SEWAGE DISPOSAL SYSTEM

HOWARD COUNTY HEALTH DEPARTMENT BUREAU OF ENVIRONMENTAL HEALTH

P 49074
A REPAIR

REPAIR - PURPOSE - TO ESTABLISH ADEQUATE SEPTIC CAPACITY TO SUPPORT ADDITION - BUILDING

SITE PLAN
STRANGE RESIDENCE
11710 WAYNERIDGE CT.
FULTON, MD 20759
LOT #9 - SECTION II
MOORESFIELD

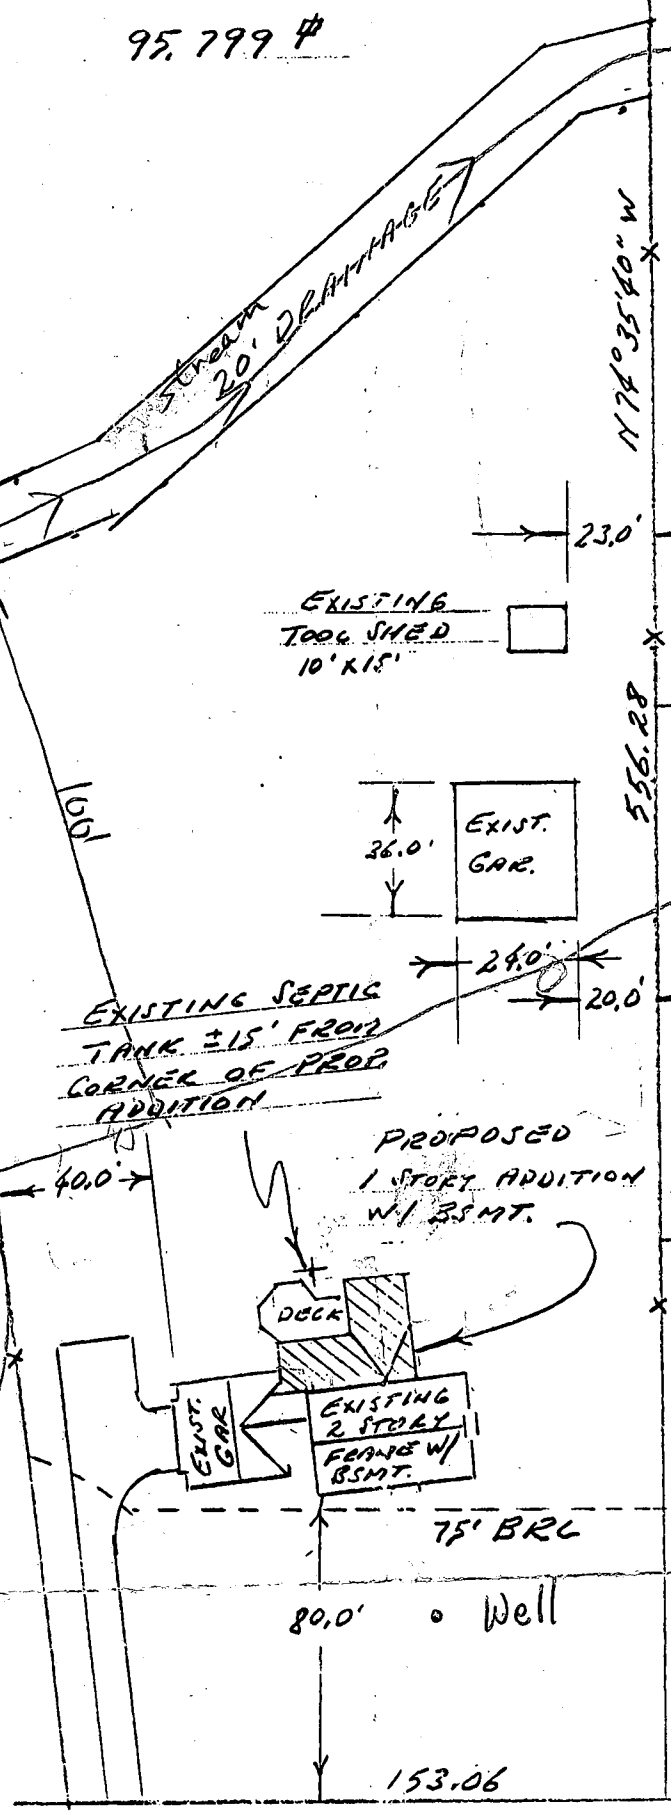
I Recommend holding decision
until get better info on
Addn location & size, use
PP 2-29-93
Need precise bearing (t. scale)
of all Addn. Also show
distance to
Septic. High 10' ST-Addn
available. However, 100'
setback from stream
severely limits available
Septic repairs
SCA Approx 40' x 130' less
loss to landscape topography)
also only 7500 sq ft.
How much of a Addn
is Addn t will there?
No Septic problem evident at
this time.

BUILDING PERMIT
APPLICATION
REJECTED
SEE OTHER SIDE R/D

COULD NOT FIND 2ND WELL

TANK FULL

EDGE OF TANK
UNDER FUTURE
ROOM ADDITION
